### **Release Note**

Edgecore EAP105 Release v12.6.5

Document # EAP105-v12.6.5-12.6.5-2506-1ff6b1531-ec1b38a

Enhancement from v12.6.3-2386-73ec2ed0-d9c6975

#### 1.1 Support Wireless and BLE Presence Data

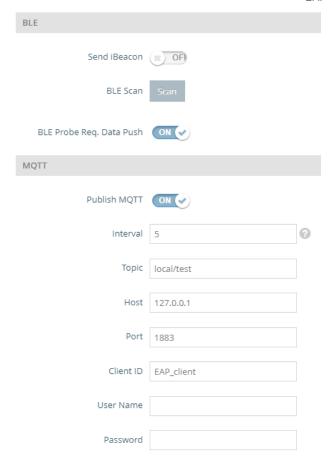
In ecCLOUD, on the radio settings page, if Probe Req. Data Push is enabled, the 2.4GHz or 5GHz radio probe data can be pushed to a URL or an MQTT server.

On the service settings page, if BLE Probe Req. Data Push is enabled, the BLE scan data can be pushed to a URL or an MQTT server.

The MQTT interval can be set between 5 and 600 seconds.
